Technical Memorandum

Prepared For: Eureka County Board of Commissioners

Prepared By: Carol Oberholtzer (Lahontan GeoScience, Inc.)

Date: November 24, 2010

(Note: Figure modified to show 5-ft contour for Cumulative and Mine-only pumping scenarios)

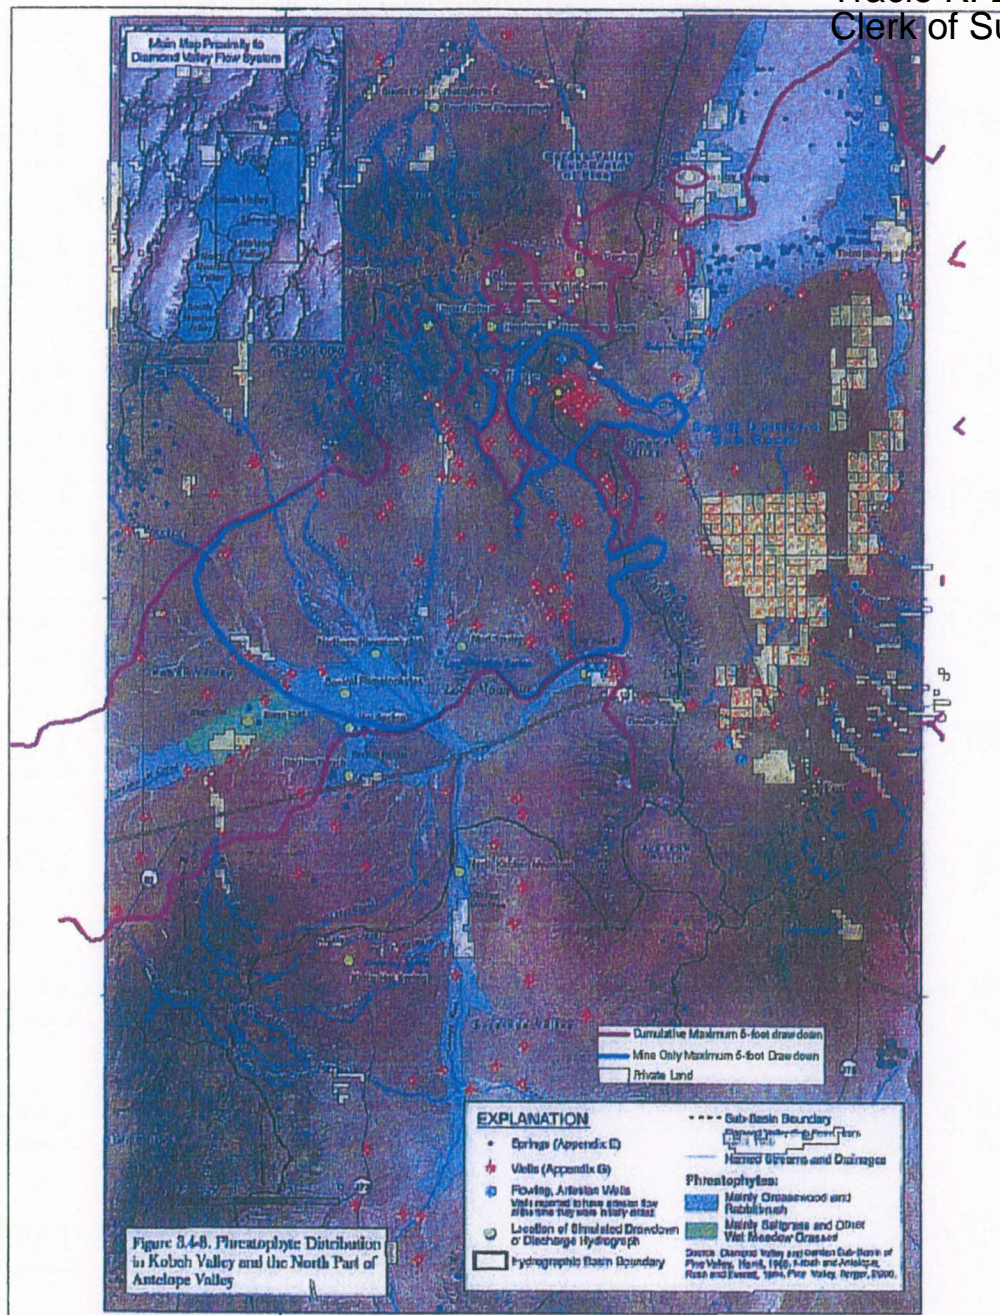
Figure 3.4-8 below shows locations of wells and springs located within the 5-ft mine-only drawdown contour calculated by the County's consultant team.

Comparison with Figure ES-5 shows an additional five wells and the Grub Flat area potentially impacted by the mine's pumping.

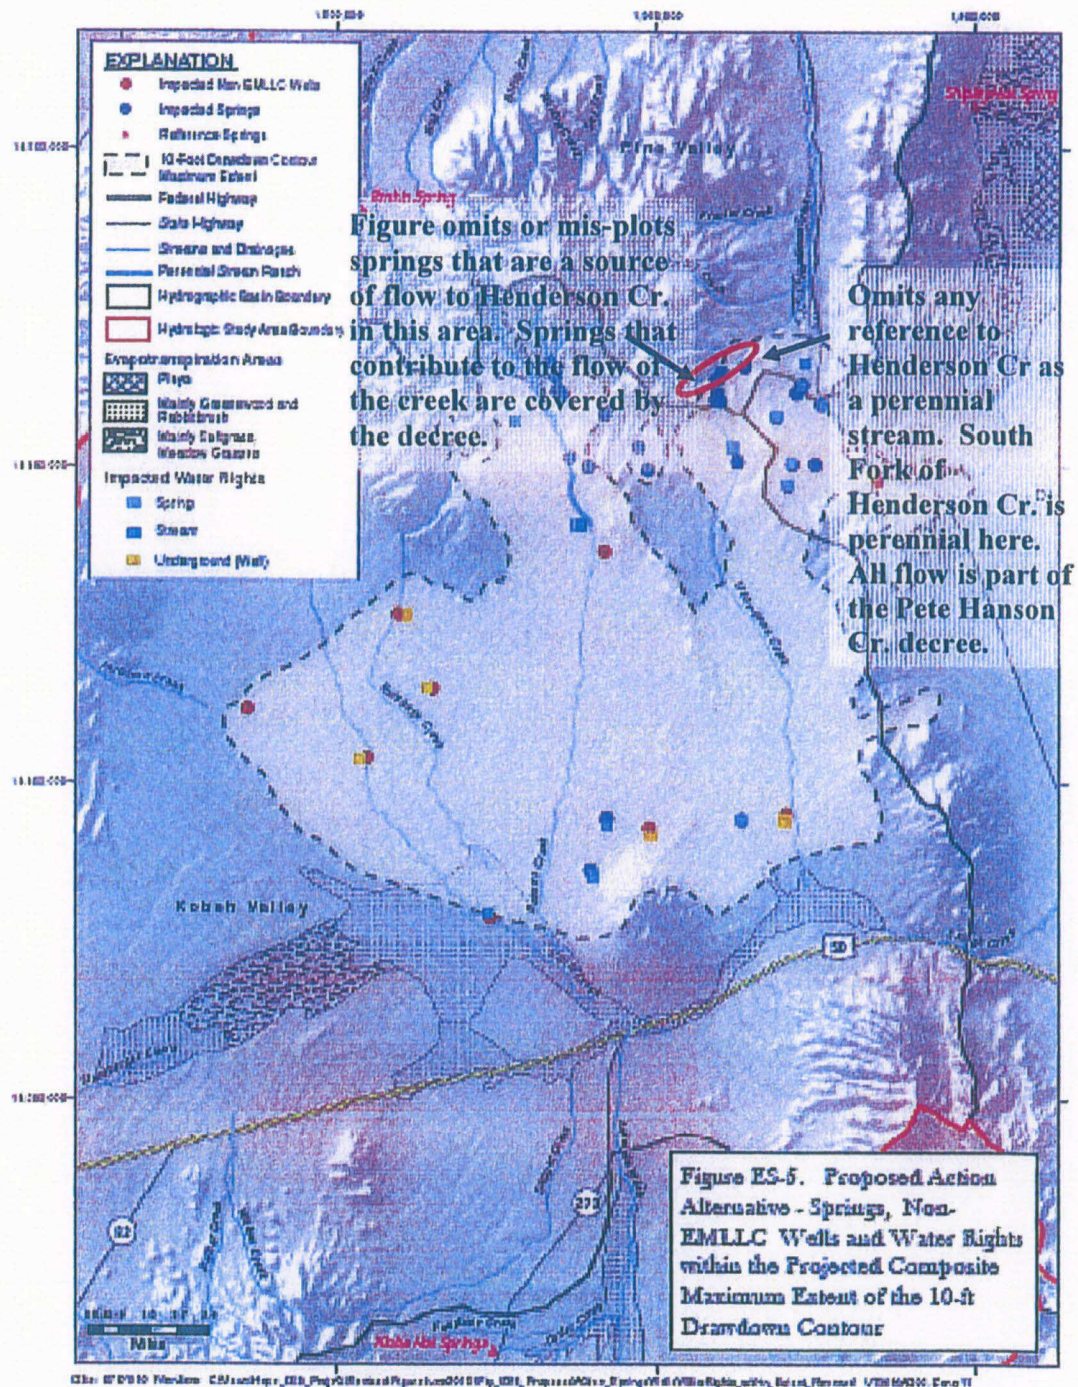
The list of potentially impacted water rights (those rights within the projected maximum extent of the 10-ft drawdown contour) ignores the decreed water rights associated with Henderson Creek (*ibid.*, Figure ES-5 and Table 4.4-9). The projected maximum extent of the 10-ft drawdown contour extends into the headwaters of Henderson Creek, actually extending north of the stream in one area. 100% of the water in Henderson Creek is subject to the Pete Hanson Creek Decree, including **all** springs that contribute to the flow in the creek whether or not they are specifically identified. The recent 9th Circuit Court of Appeals decision (USA v. Orr Ditch Company; 600 F.3d 1152 (9th Cir. 2010)) prevents the State Engineer from approving any water rights applications that affect decreed water rights. Because the mine's model clearly simulates impacts to flows in the springs, based on the mine's proposed pumping, it is unclear how the State Engineer can approve the current applications.
